1. Response to ExA's second written questions
2. Comments on the applicants submissions received by deadline 4
3. Comments on draft DCO

# Aldington and Mersham Support Group Submission for Deadline 5 (15<sup>th</sup> April 2025)

**Plan showing BMV Land, 58m Contour and BESS Infrastructure**

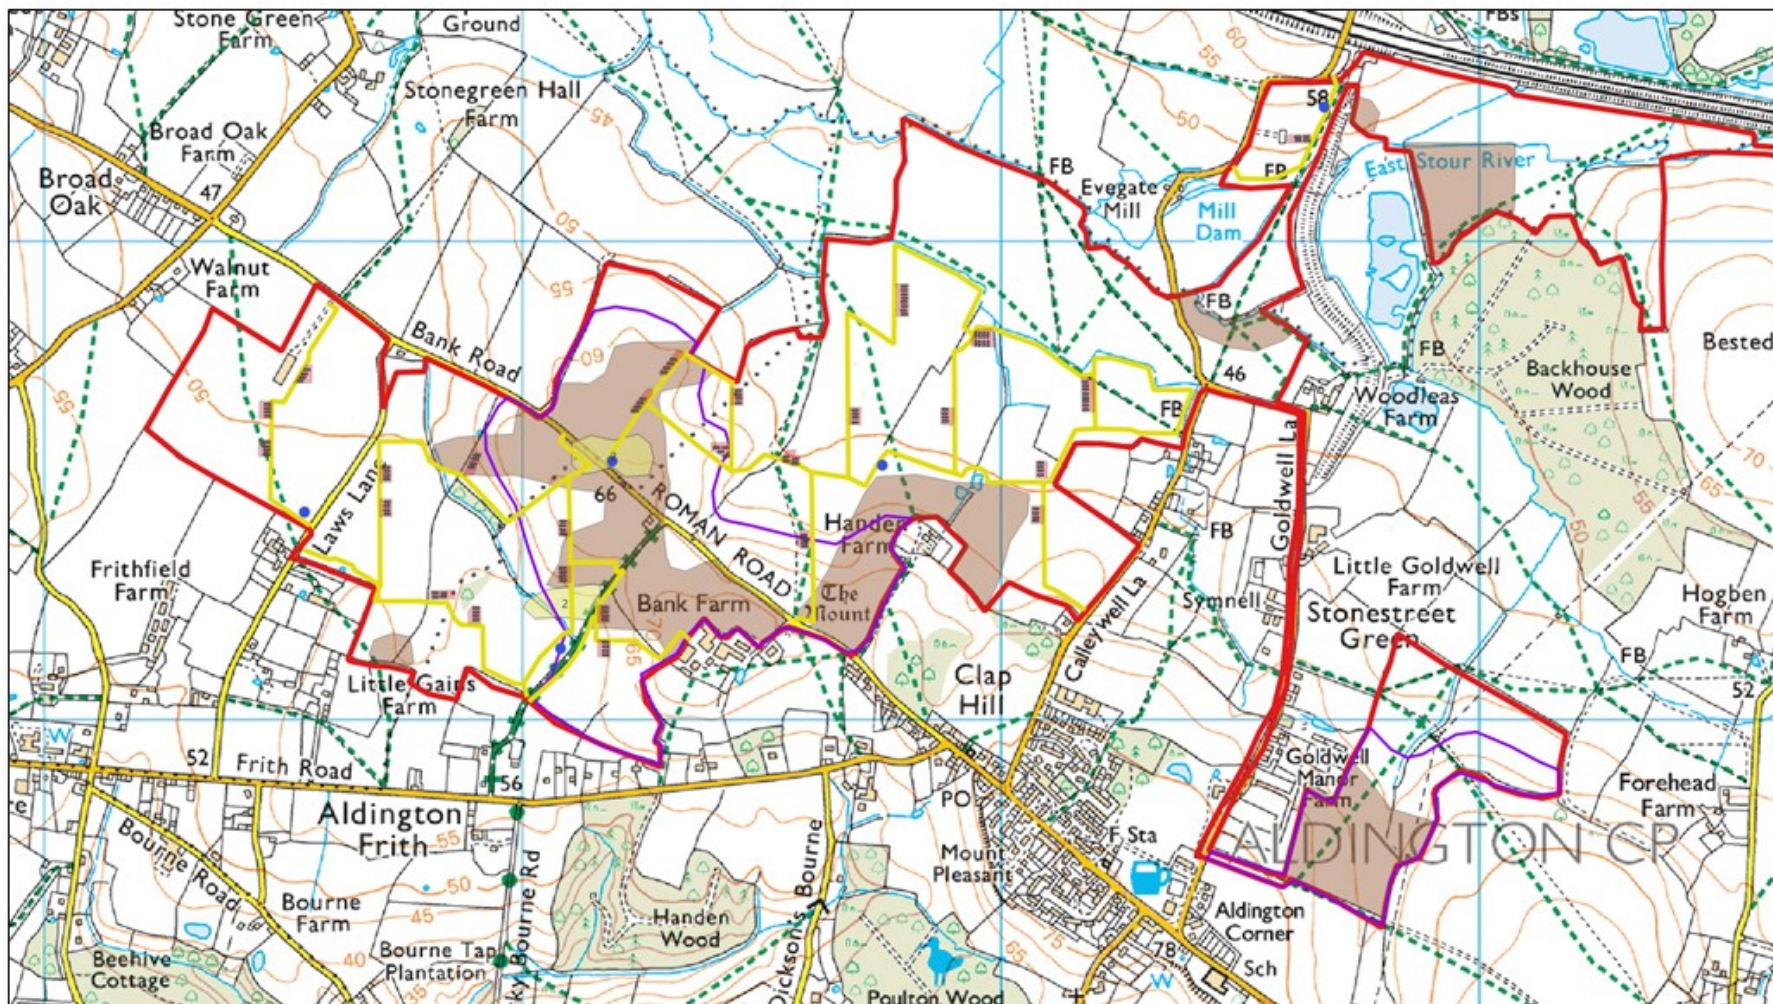
- Using the data from the Applicants soil analysis report (**APP-122**) 20.3% of the DCO limits is made up of BMV land.
- 68% of the BMV land within the DCO limits is located on the Aldington Ridge as defined by the 58m elevation contour (see plan below).

- If the land above 58m were excluded from the scheme, the percentage of BMV land utilised would reduce to 8%, with the overall area of the project reduced from 187 to 149 hectares.

- With regards to the location of structures on BMV land, there are five battery enclosures and one water tower located on BMV land (see plan below).
- In addition, 1.2 km of grass-crete roadways will be built across BMV land to access the battery enclosures, which given their construction should be considered structures.

- As outlined in our submission for Deadline 1 (**REP1-109**), the Applicant has missed the opportunity to design a scheme that by excluding land above 58m would not only preserve BMV land, but also significantly reduce visual impact, preserve important heritage assets along Roman Road and critical Skylark habitats.
